22 May 2024

ADDENDUM NO. 1

**SCOTTS VALLEY WATER DISTRICT
SCOTTS VALLEY TRANSIT CENTER
LOW IMPACT DEVELOPMENT (LID) RETROFIT PROJECT – PHASE 2**

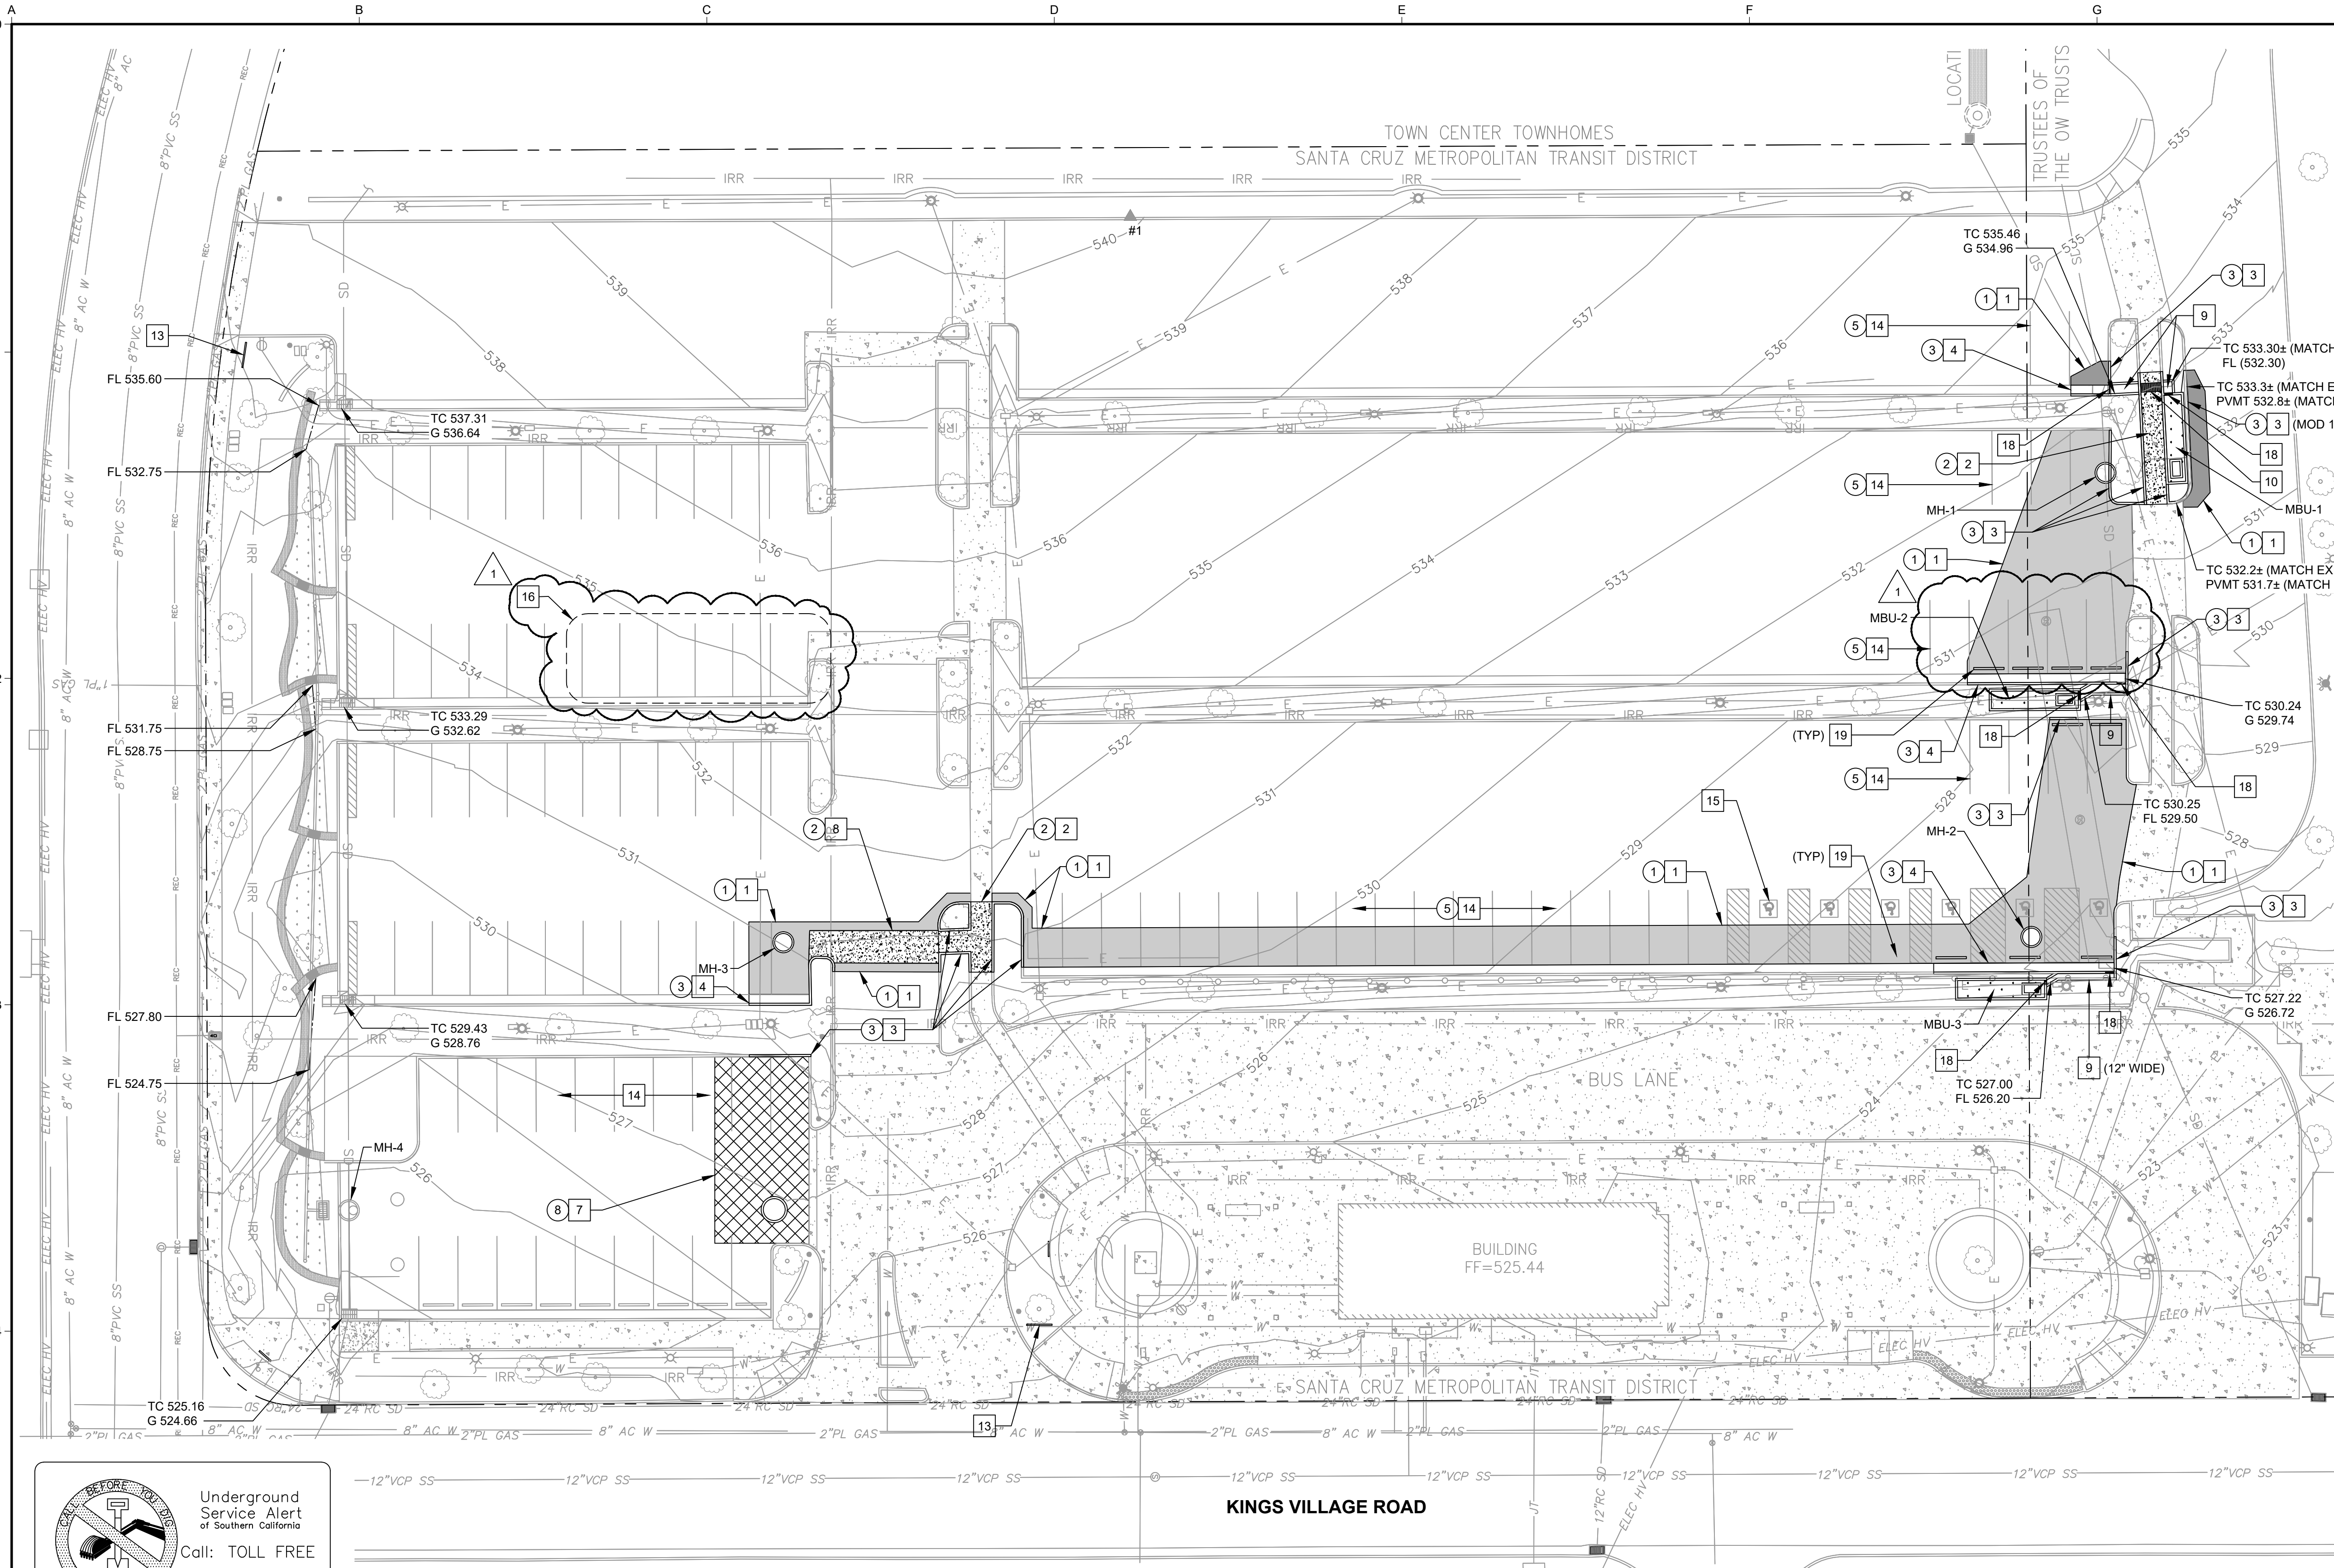
1.04	Sheet G1.2	DELETE Sheet G1.2 in its entirety and in its place ADD the attached Sheet G1.2 that includes delta-1 dated 05/2024 in its revision block. Revisions generally include edits to the Construction Sequencing Notes.

- INSTALL TEMPORARY PROJECT IDENTIFICATION SIGNS SHOWN ON C9.3.
- RELOCATE ADA PARKING STALLS TO TEMPORARY ALTERNATE LOCATION SHOWN ON C1.1.
- CONSTRUCT SOUTH SIDE IMPROVEMENTS, INCLUDING CONVEYANCE PIPELINE AND MODULAR BIOFILTRATION UNITS.
- UPON COMPLETION OF SEQUENCE 3, RELOCATE ADA PARKING STALLS TO THE PERMANENT LOCATION.
-
- CONSTRUCT THE HYDRODYNAMIC SEPARATOR, AND ITS CONNECTION TO MH-3 AND THE EXISTING INFILTRATION GALLERY, AND RESTORING THE PVIOUS PAVEMENT.
- LANDSCAPING TO BE PHASED AND COMPLETED IN CONJUNCTION WITH SEQUENCE 2 THROUGH SEQUENCE 6 ABOVE.
NOTE: FOR ALL CONSTRUCTION ACTIVITIES IN ALL PHASES OF THE WORK, THE MAXIMUM NUMBER OF STANDARD STALLS THAT MAY BE TEMPORARILY REMOVED FROM PUBLIC USE IS 36. ALL OTHER SPACES MUST REMAIN ACCESSIBLE FOR PUBLIC USE. CONTRACTOR SHALL STAGE WORK ACCORDINGLY.

JOB NO: 2468009.00
 DATE: MAY 2024
 SHEET: 3 OF 27
C1.1

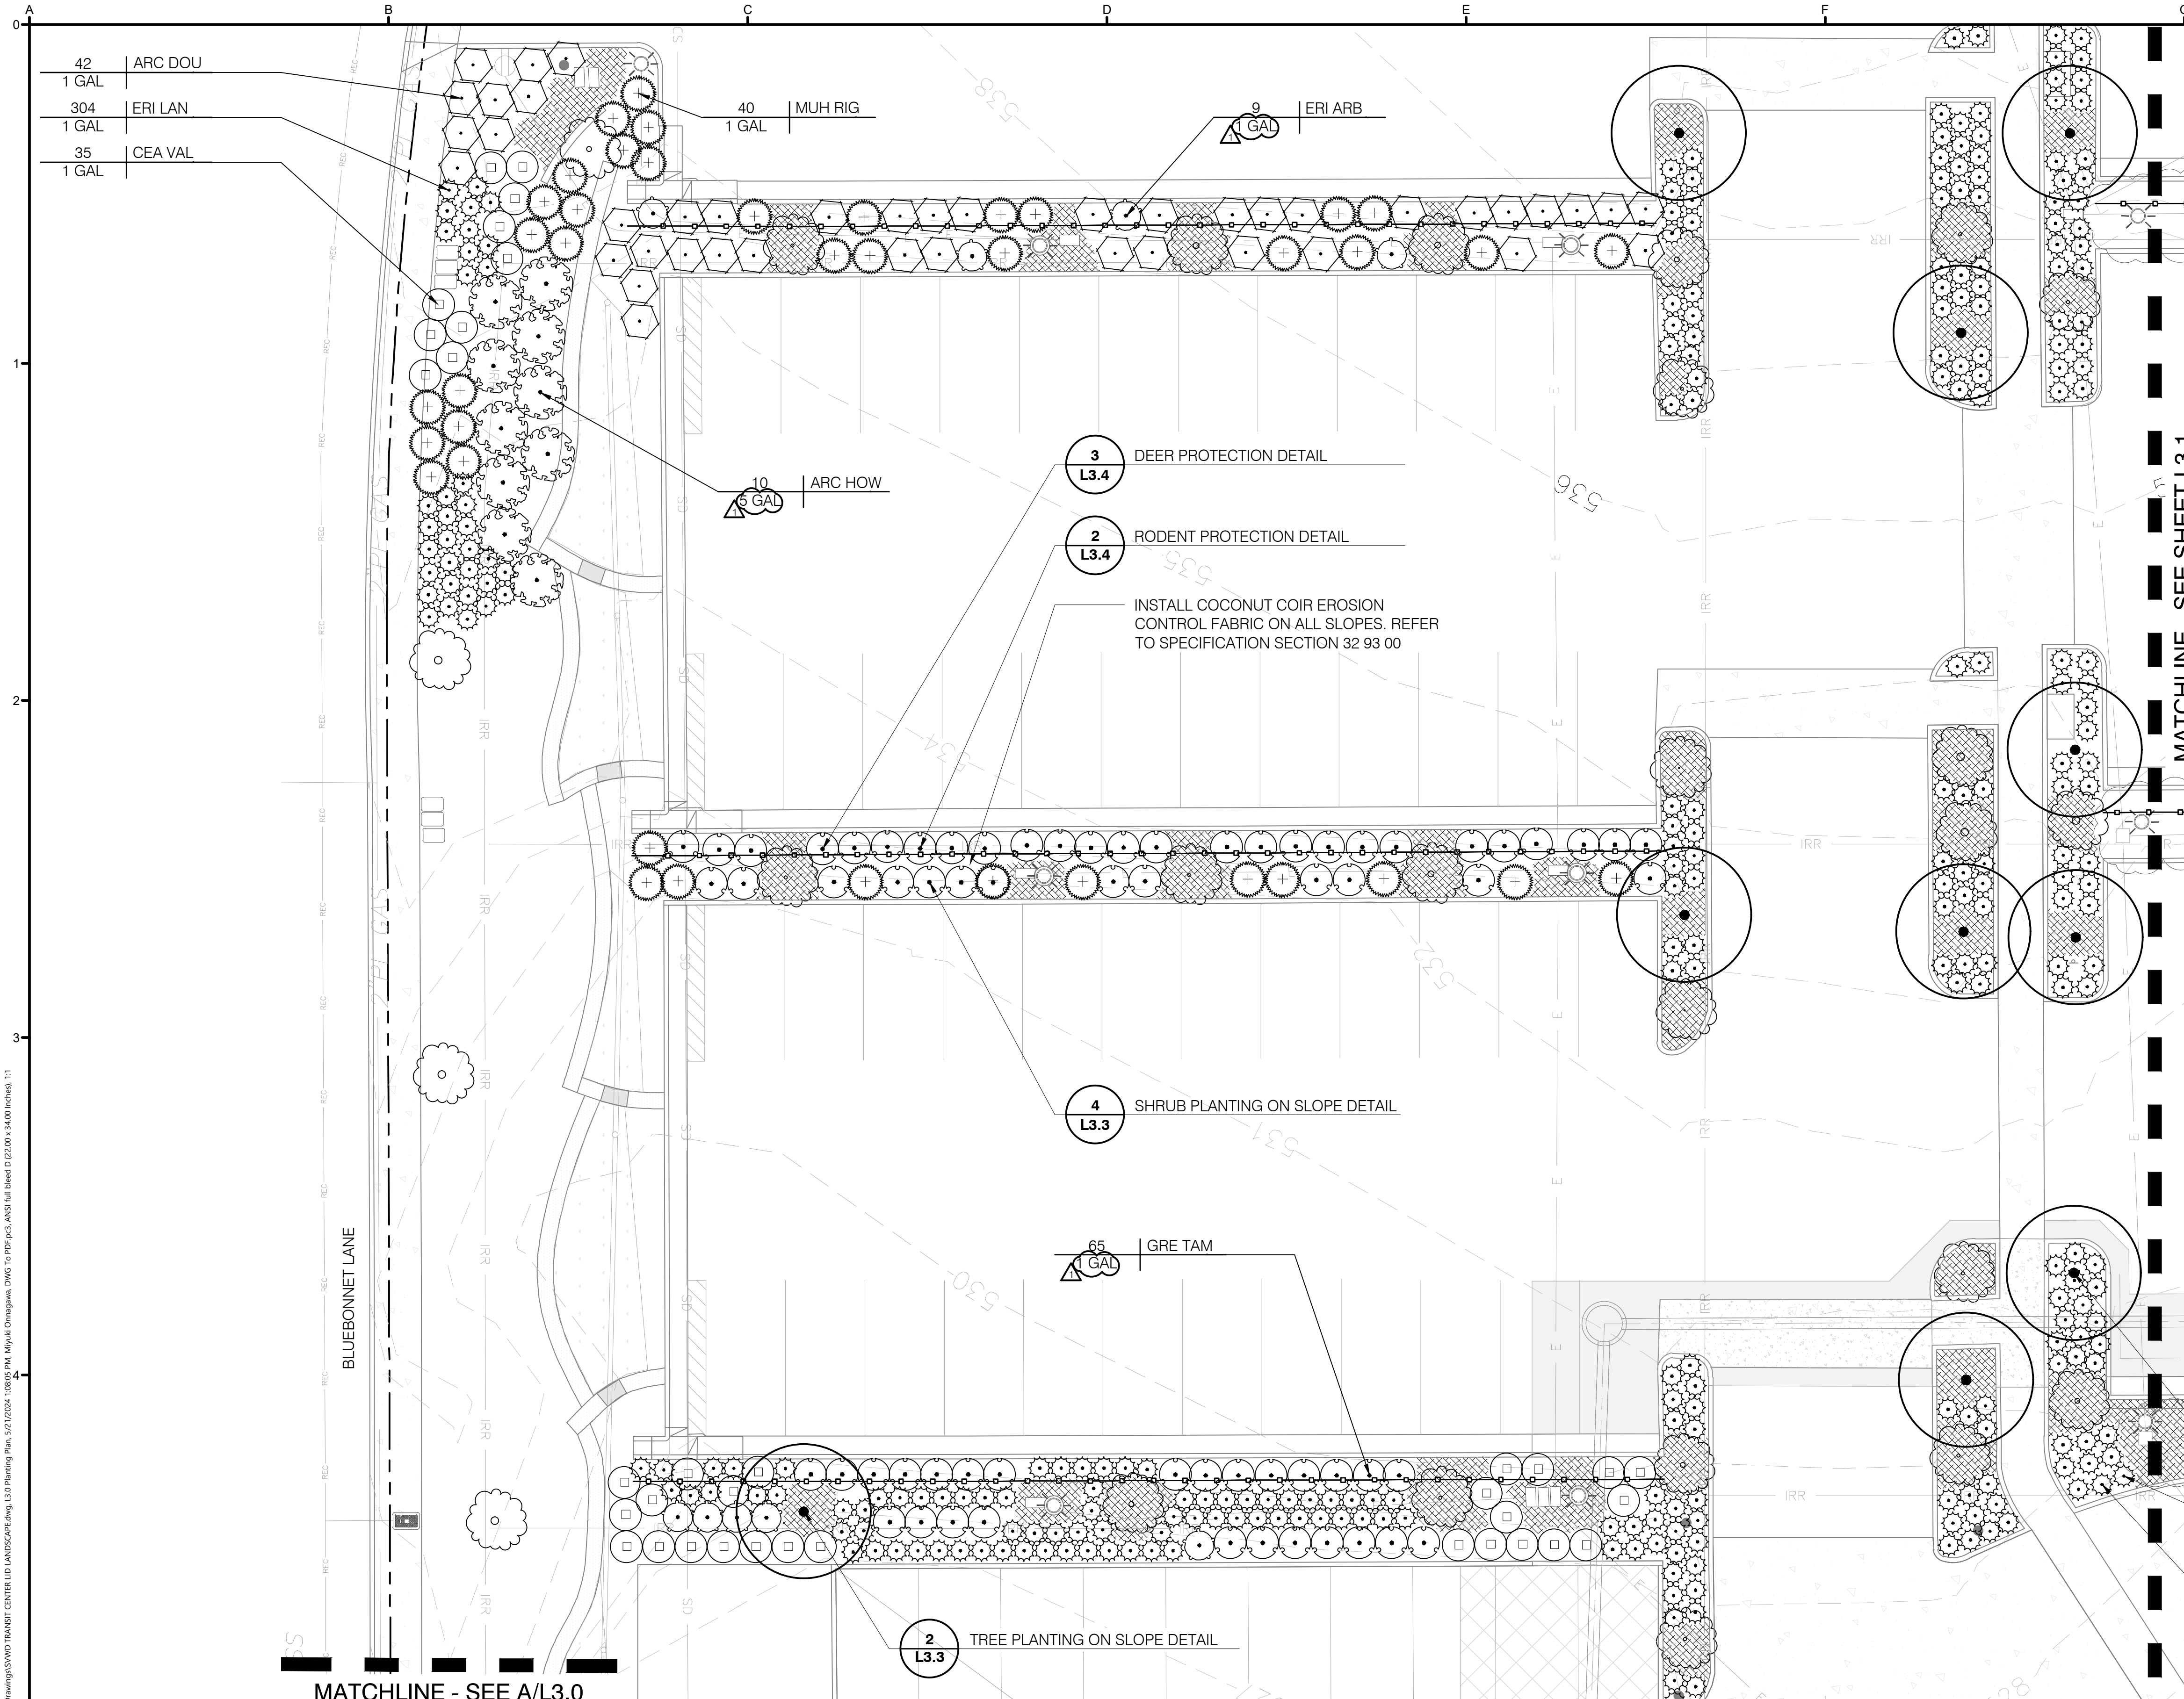
1.05	Sheet C1.1	DELETE Sheet C1.1 in its entirety and in its place ADD the attached Sheet C1.1 that includes delta-1 dated 05/2024 in its revision block. Revisions generally include revising the location of the temporary ADA parking.

- INTERNATIONAL HANDICAP SYMBOL PAVEMENT MARKING. 4" WHITE STRIPING AND BORDER ON SOLID BLUE BACKGROUND. 4 FOOT SQUARE.
 - TEMPORARY ADA PARKING STALLS WHEN PERMANENT STALLS ARE NOT USABLE DURING CONSTRUCTION. PROVIDE 6 STALLS AT 9' WIDE EACH WITH 5' (MIN) AISLES BETWEEN. PROVIDE PAVEMENT MARKINGS AND SIGNAGE CONSISTENT WITH ADA STALL REQUIREMENTS. WHEN PERMANENT STALLS ARE RESTORED TO FULL TIME USE, REMOVE ALL ADA MARKINGS AND SIGNAGE AND STRIPE AS SHOWN FOR PERMANENT STANDARD STALL USE.
